STATE OF WASHINGTON  
DEPARTMENT OF ECOLOGY

February 19, 2020

**Re: Further Action at the following Site:**

- **Site Name:** Mutual Materials Newcastle Lot 4 Cr Site
- **Site Address:** 6620 Coal Creek Parkway SE, Newcastle, WA 98056
- **Facility/Site No.:** 50608
- **Cleanup Site ID No.:** 15081
- **VCP Project No.:** NW3248

Figure 2 Site Plan and Soil Excavation Area (EPI, 2019)

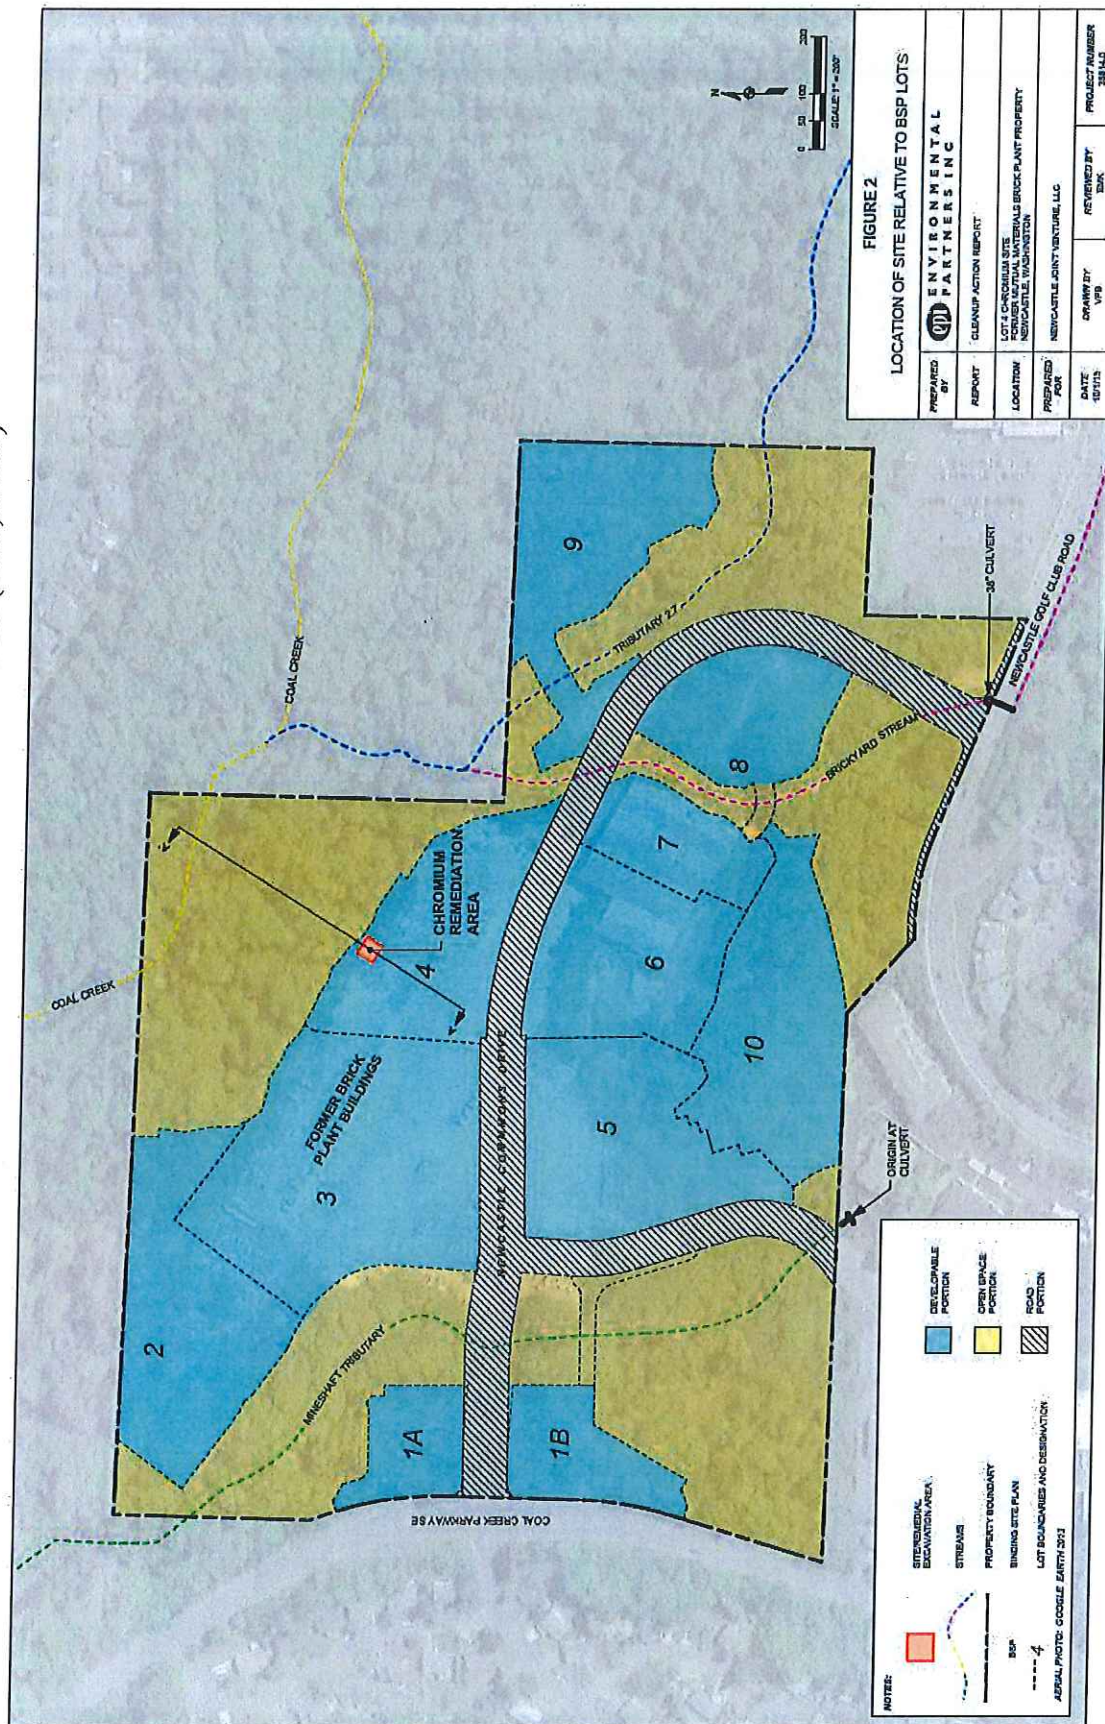
- Chromium detected in soil was determined as the chemical of concern (COC), at the maximum concentration of 98 mg/kg in a composite sample from Test Pit TP-32, which was analyzed in 2012. The source of the contamination was identified as waste brick debris and product stored at the Site (**Enclosure A, Figure 2**), which resulted from the historical brick manufacturing operation approximately between 1957 and 2011.
- The soil impacted with chromium was defined and limited to an area of approximately 361 square feet within the Property and was not detected above the applicable cleanup level in confirmation samples collected at 3 to 6 feet below ground surface (bgs; see **Enclosure A, Figure 4**).

**Ground Water:** Ground water was not encountered in the Site investigation and the soil excavation, but it is likely present at approximately 15 feet bgs. The estimate is based on the ground water table existing at depths ranging approximately from 17 to 26 feet bgs at the Lot 4 Dry Well Site (VCP NW3247) immediately adjacent to this Site. The ground water flow direction is also likely to the north toward Coal Creek (**Figure 2**).

Figure 3 Soil Contaminated by Chromium at the Site (EPI, 2019)

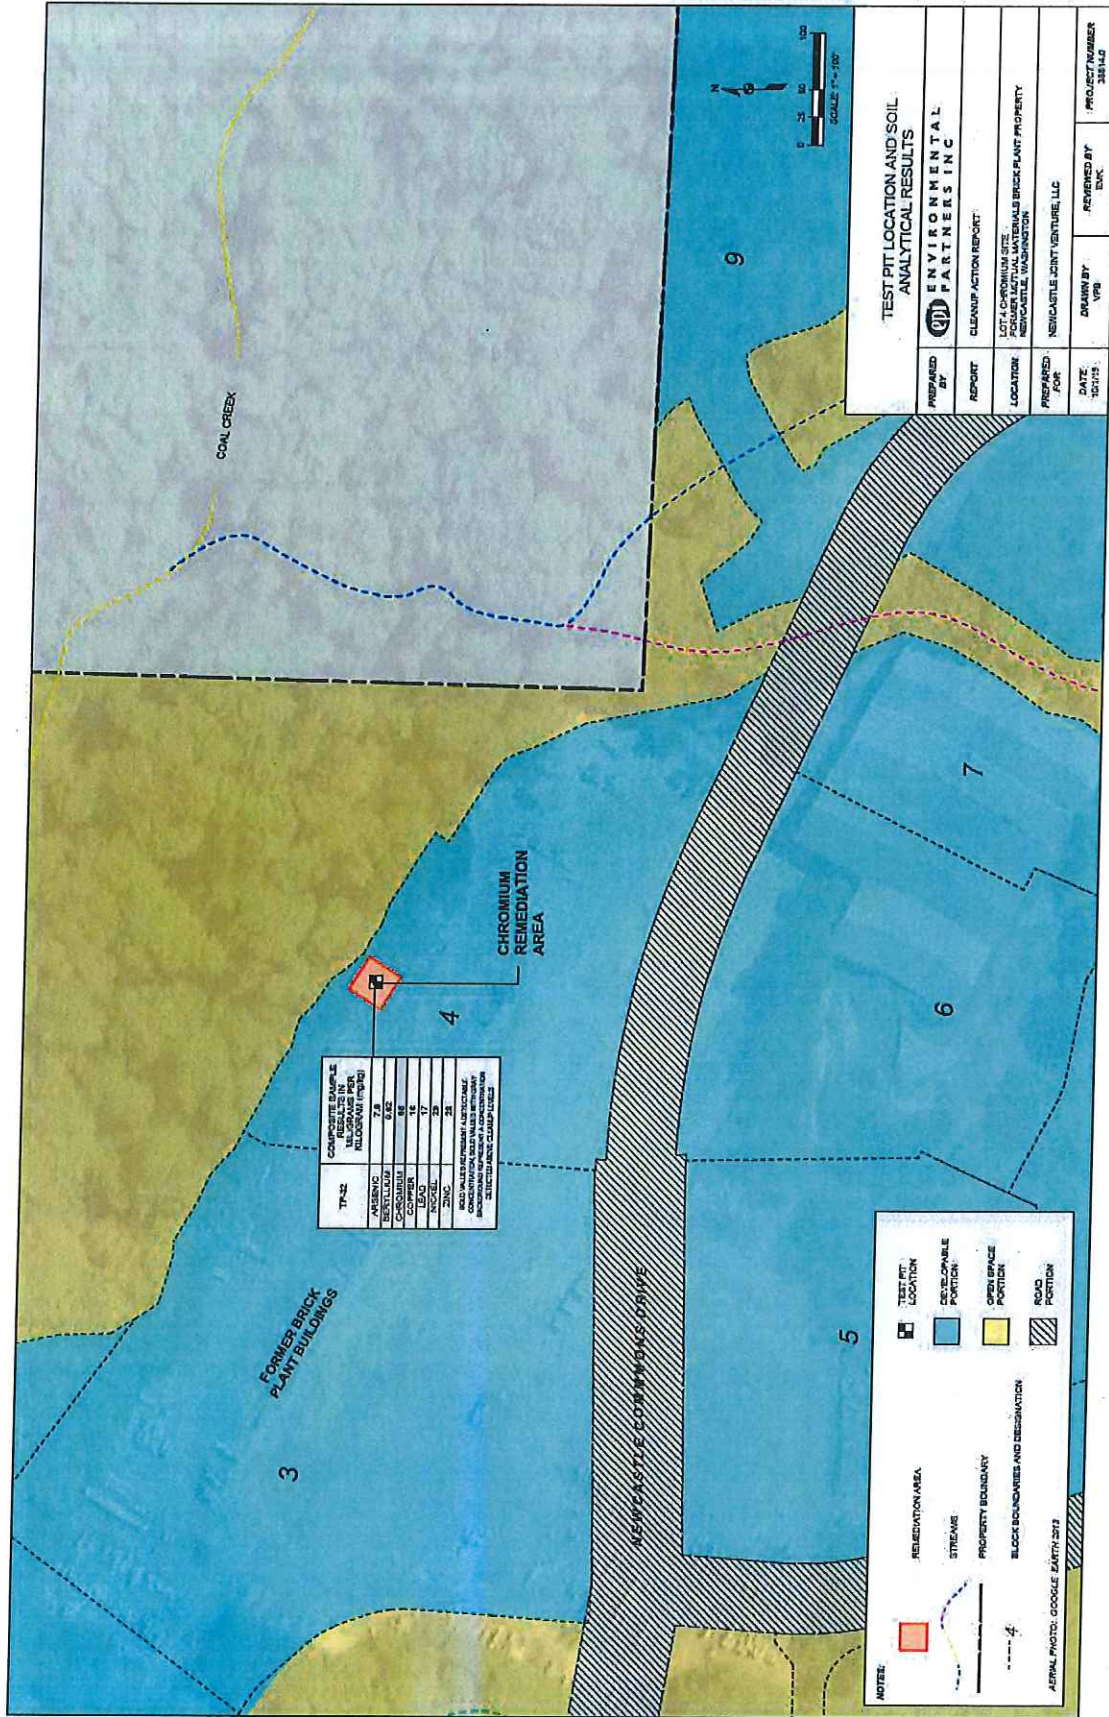
- Revisions
  - Ground surface elevation at TP-32
    - Stated in the CAR report text and Figure 3 (Cross Section A-A') as 390 feet above mean sea level (amsl).

- King County IMAP and the Lot 4 Dry Well report (VCP project, NW3247) both show ground surface elevation as 375 feet amsl.
    - Revise text to identify ground surface elevation as 375 feet amsl.

- Revise Figure 3, including expanding the vertical scale, to show the following:
      - Ground surface elevation of 375 feet amsl.
      - Depth, lithology, soil sample locations, and the associated chromium concentrations for test pit TP-32.

- Depth, lateral extent, lithology, soil sample locations, and chromium concentrations for the remedial excavation (3 feet deep at the margins and 6 feet deep at the center).

- Ground water elevation, reported on the adjacent Lot 4 Former Dry Well Site (NW3247) at 360 feet amsl.

Figure 4 Soil Excavation Boundary and Confirmation Sampling Locations at the Site (EPI, 2019)

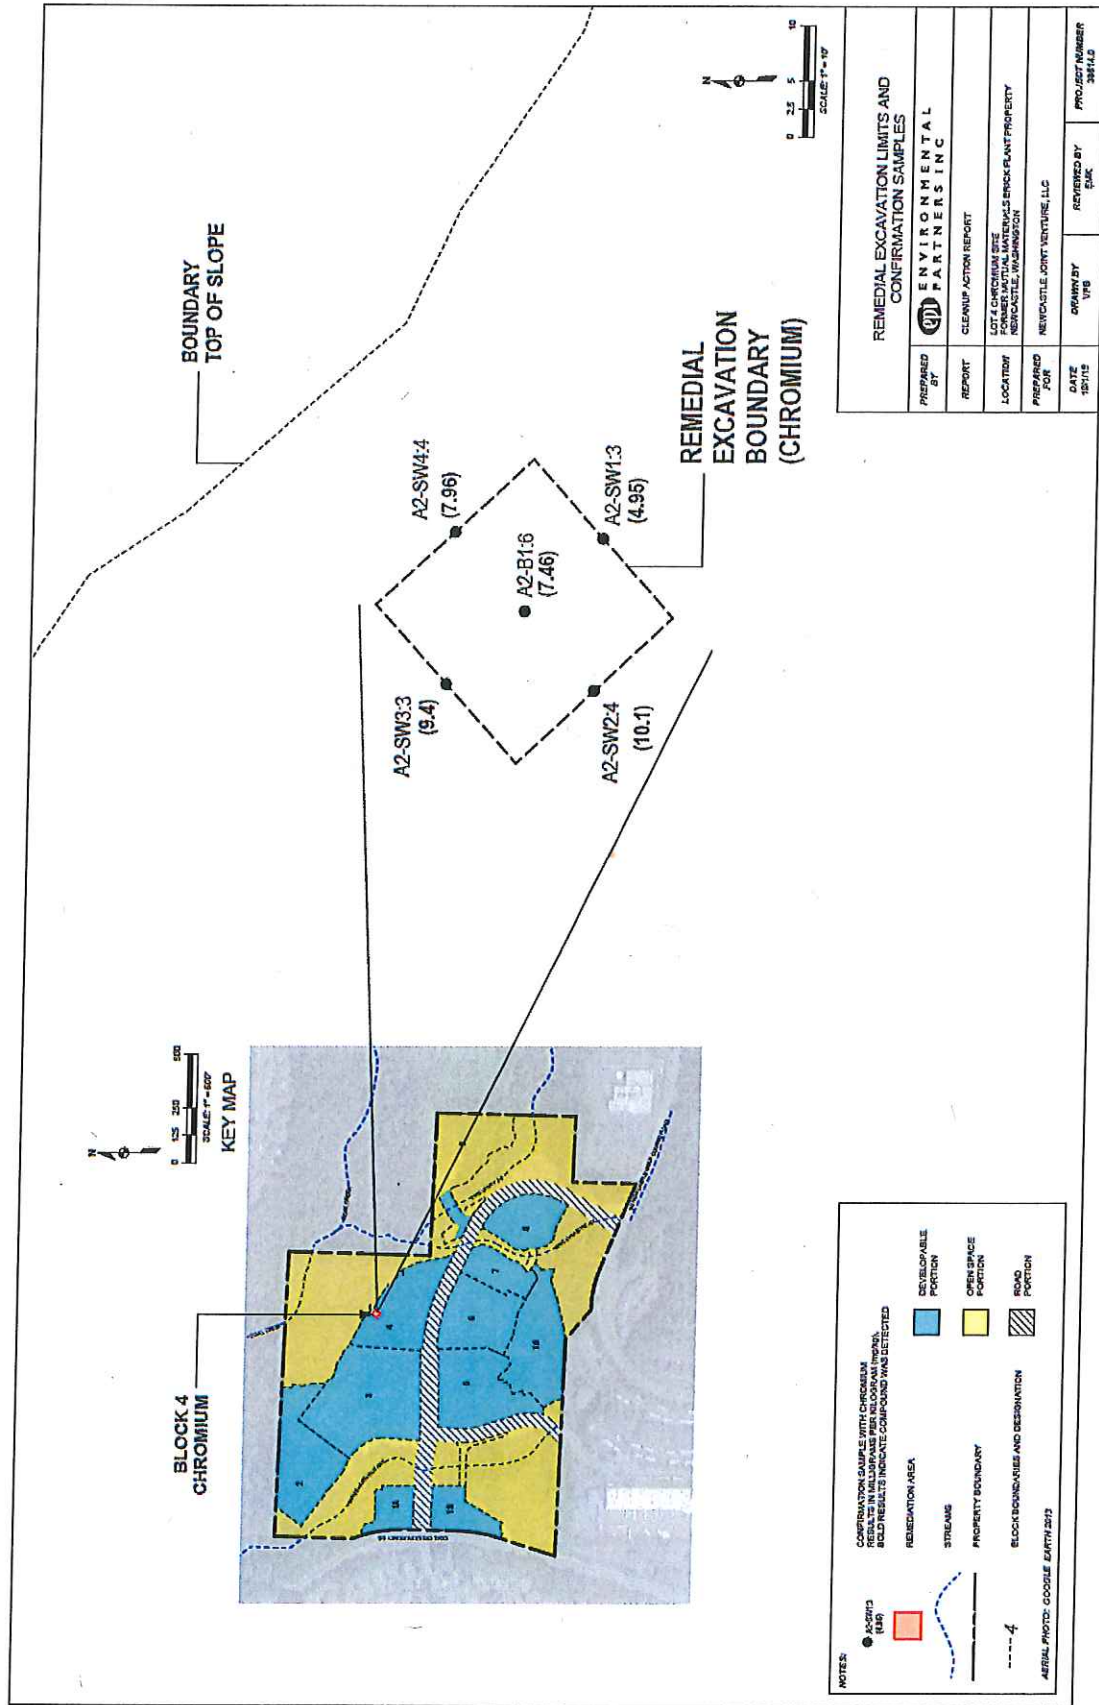
- The remedial excavation was a square with an area of approximately 19 feet long, 19 feet wide, and 6 feet in depth (**Enclosure A, Figures 4 and 5**). In April 2015, a total of approximately 142 tons of the impacted soil was removed and disposed at a regulated off-Site facility.
- Five confirmation soil samples collected at bottoms and sidewalls of the excavation demonstrated that the COC was at non-detectable or below the Site cleanup levels (**Enclosure A, Figure 4**).
